Re: Technical Comments to the Draft BACT Determination  
Prepared by FDER on the Hardee Power Station

TECHNICAL COMMENTS TO THE DRAFT BACT DETERMINATION  
PREPARED BY FDER ON THE  
HARDEE POWER STATION

Figure 1 FLUE GAS EQUILIBRIUM COMPOSITIONS - GAS NO. 2

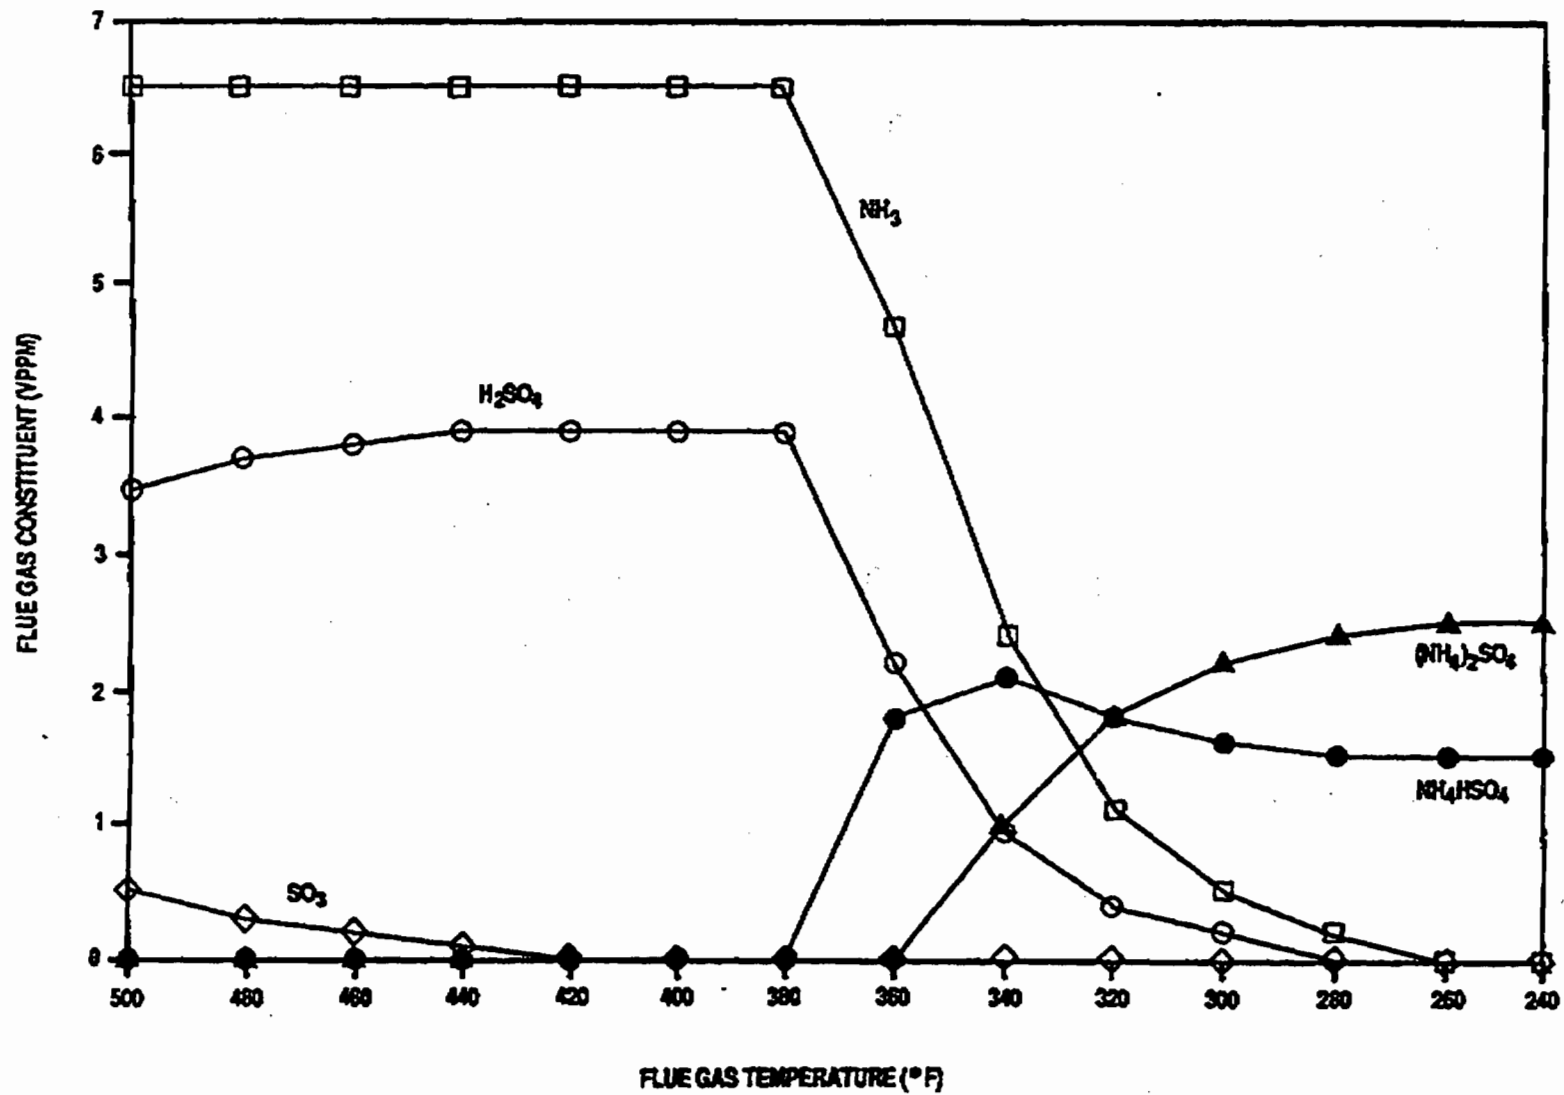
The formation of ammonium bisulfate and sulfate downstream of the SCR reactor is a complex function of gas composition and temperature. This problem was evaluated in a study recently conducted by Exxon for General Electric Company. The results of Exxon's calculations are shown in Figures 1 and 2. Both calculations used an exhaust gas composition based on firing 0.2 percent sulfur distillate oil. In Figure 1, the unreacted ammonia leaving the SCR was assumed to be 6.5 ppm, and in Figure 2 it was 13 ppm. In Figure 1, ammonium bisulfate begins to form at temperatures below  $380^\circ$ , and below  $360^\circ$ , ammonium sulfate forms as well. By the time the gas reaches  $260^\circ$ , all of the sulfur present as either  $\text{SO}_2$  or as  $\text{H}_2\text{SO}_4$  has reacted, consuming all of the excess ammonia as well. Figure 2 shows

A further problem for SCR operation associated with firing sulfur-bearing fuels is the formation of particulate matter in the SCR. For the example shown in Figures 1 and 2, the sulfate particulates would increase the PM10 emissions by 49 and 55 lb/hr for each gas turbine, respectively.

Figure 2 FLUE GAS EQUILIBRIUM COMPOSITIONS - GAS NO. 1

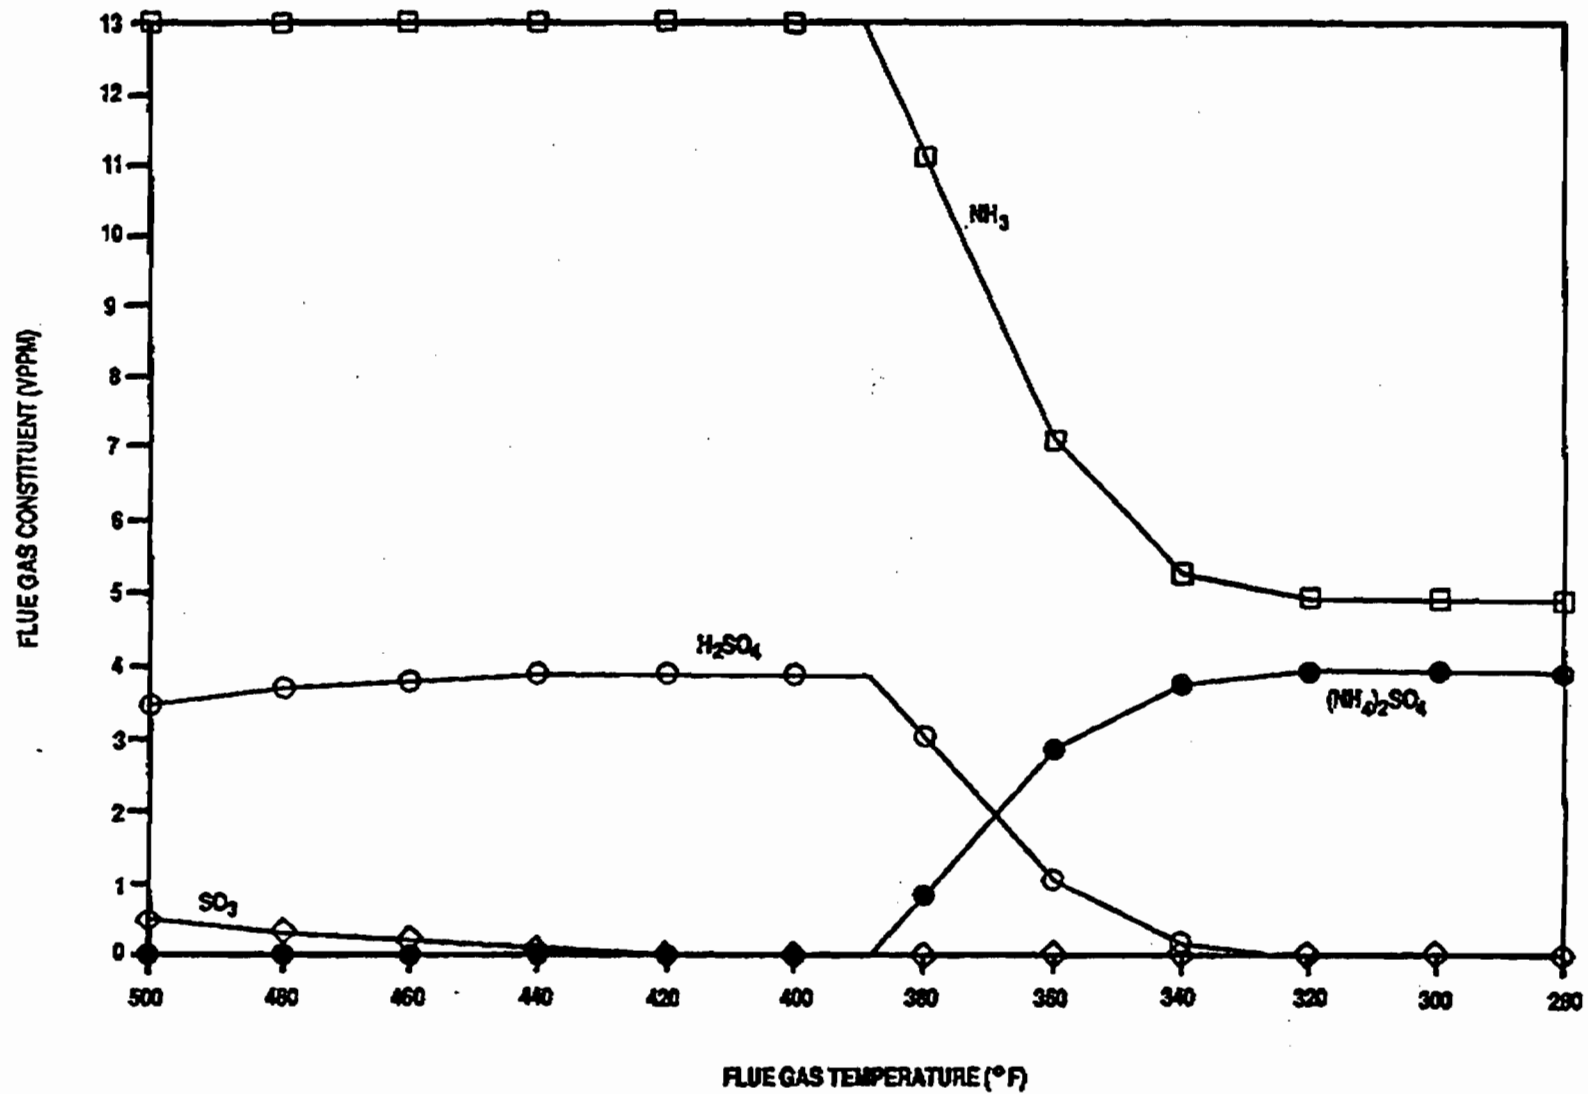
that at the higher level of unreacted ammonia, only ammonium sulfate forms but excess ammonia in the stack gases would be 5 ppm.
